FOUNDATION PLAN

This seal is for the interior bearing foundations only. Nick Geisler is engineer of record for the project. The original foundation drawing had foundation only on exterior walls. I was asked by the owner to stamp this foundation drawing showing the size and location of the interior footings. I was at the site and saw the top surface of the completed interior bearing foundations. The owner furnished photos of the interior footings taken prior to concrete pour which showed 2 top and 2 bottom rebars and dowels into the existing slab.

A CUSTOM HOME FOR
THE BECKER RESIDENCE
331 SW ROSE CREEK DR., LAKE CITY, FLORIDA 32024

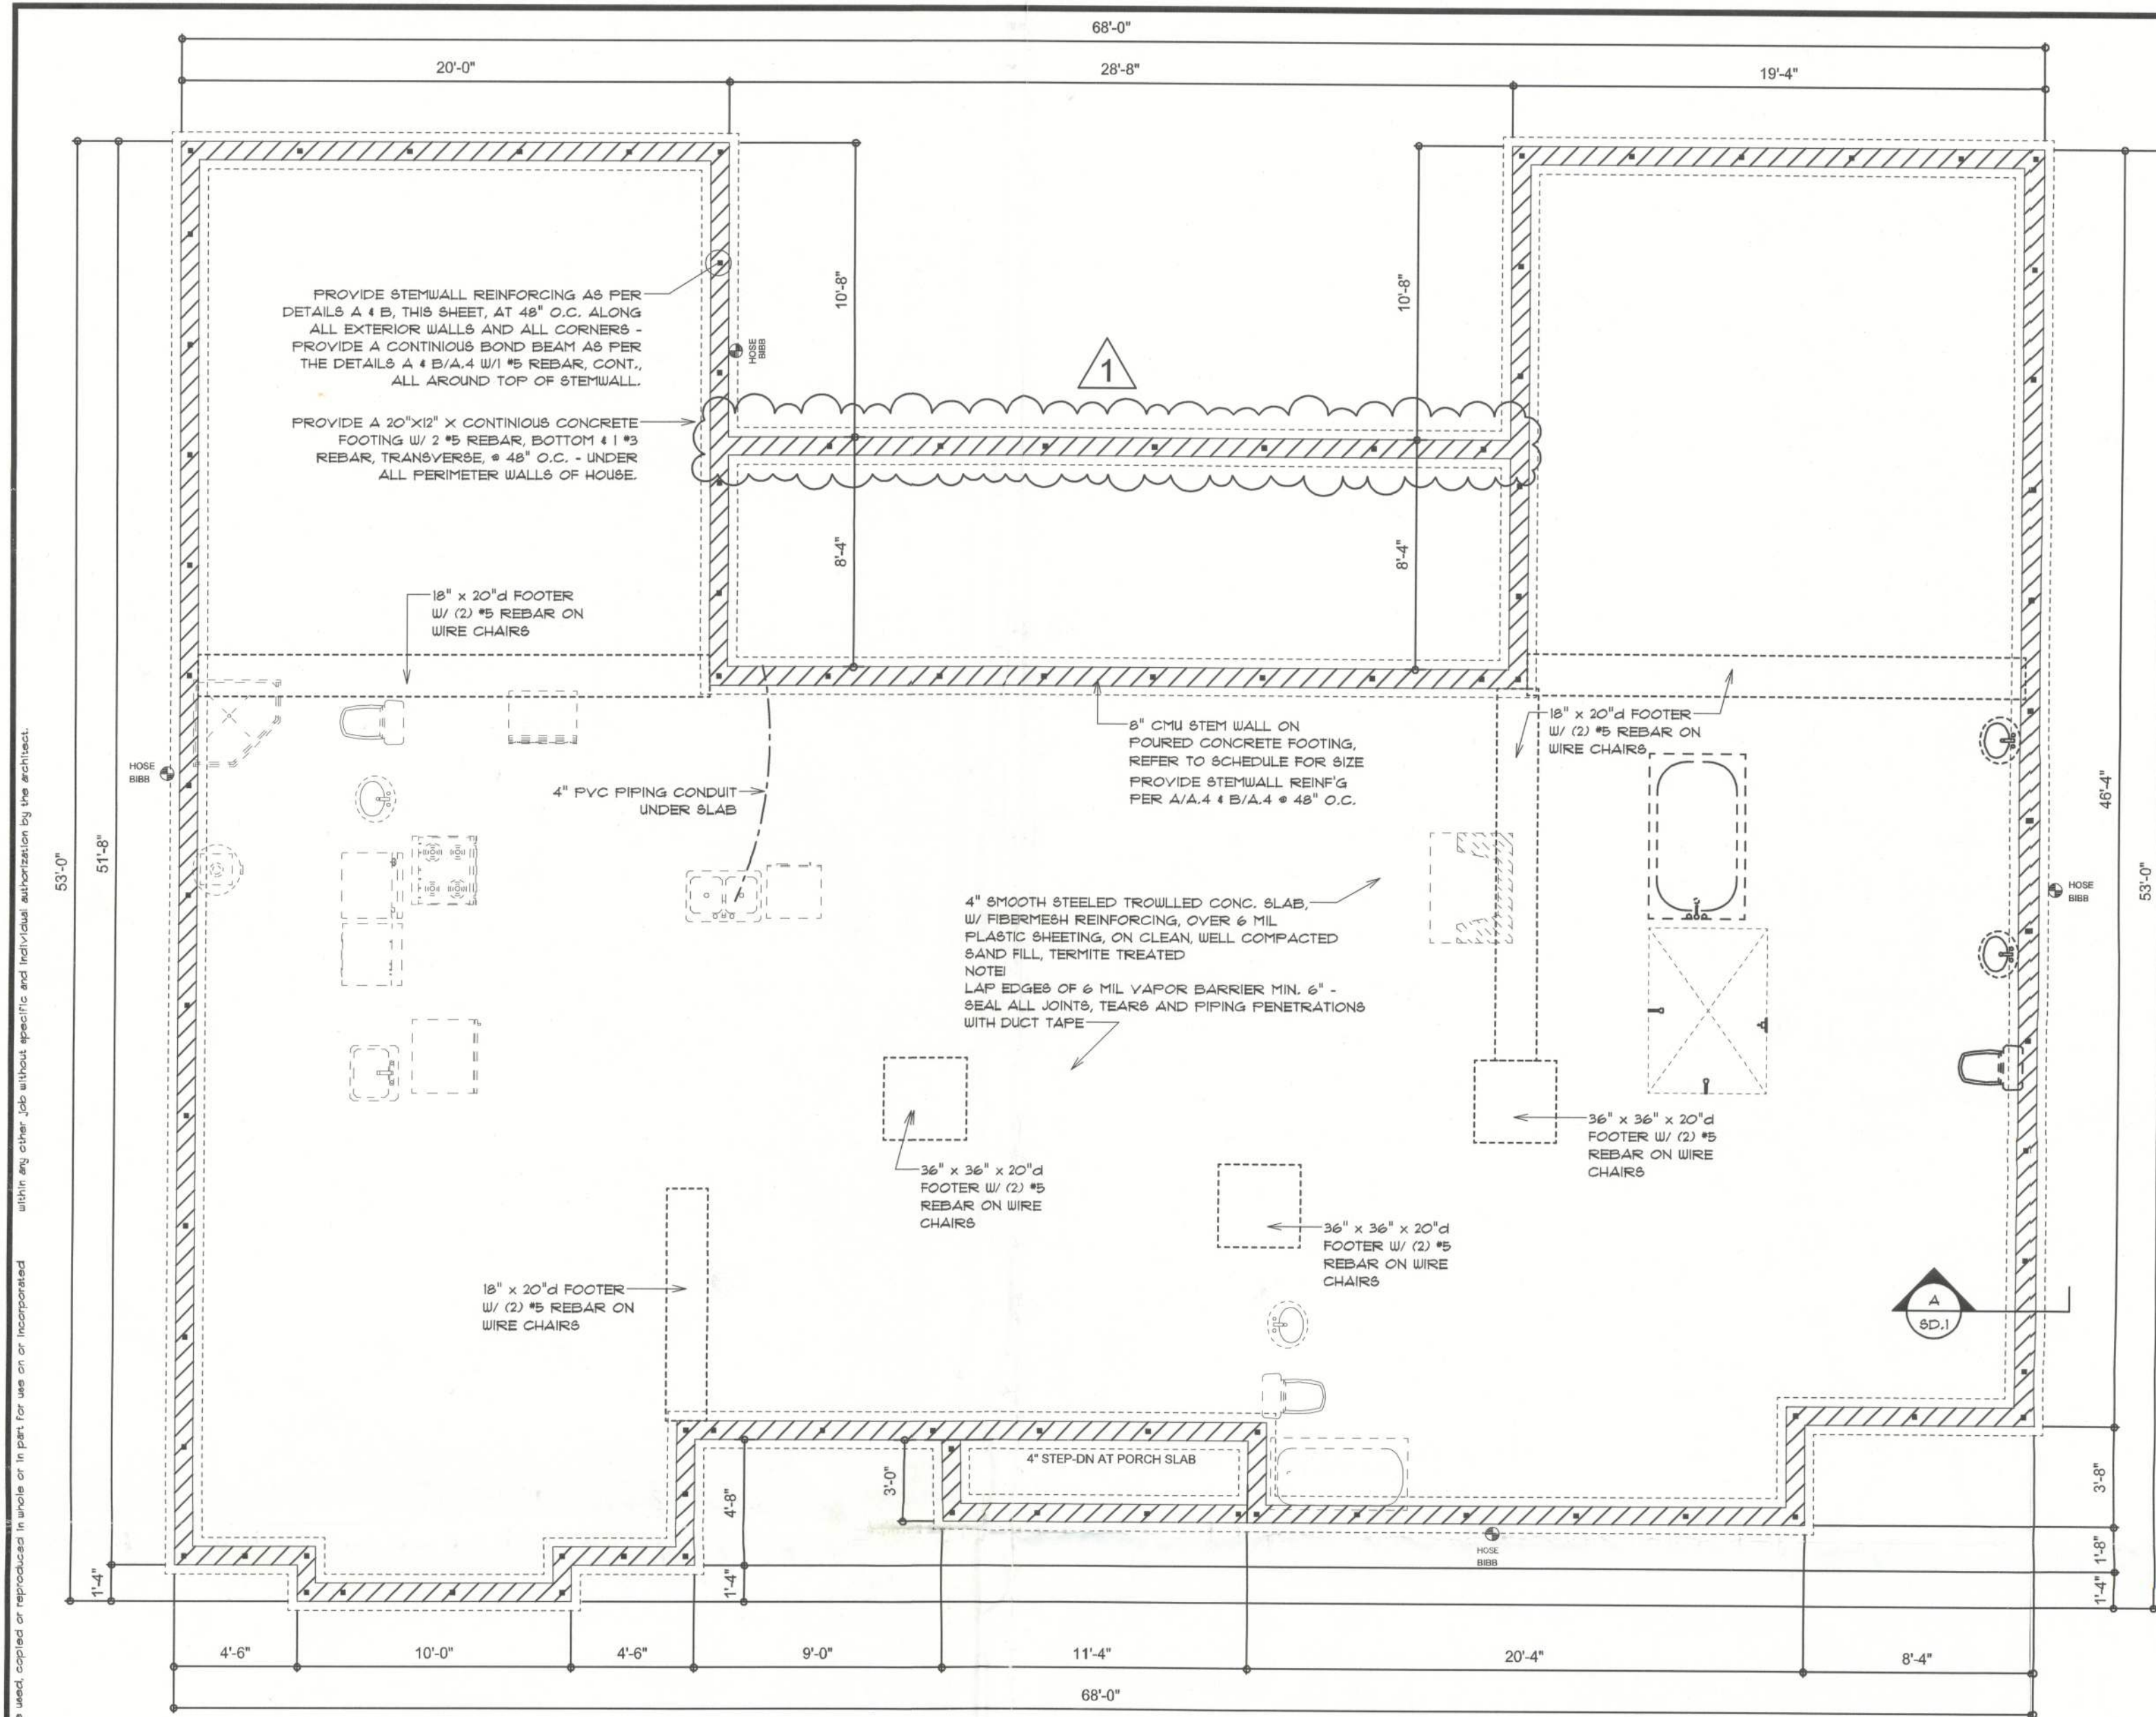
After reviewing the engineering for the roof and floor systems to see design loads and looking at the photos of footings prior to concrete pour to the best of my knowledge, "The structure is sufficient in its current state."
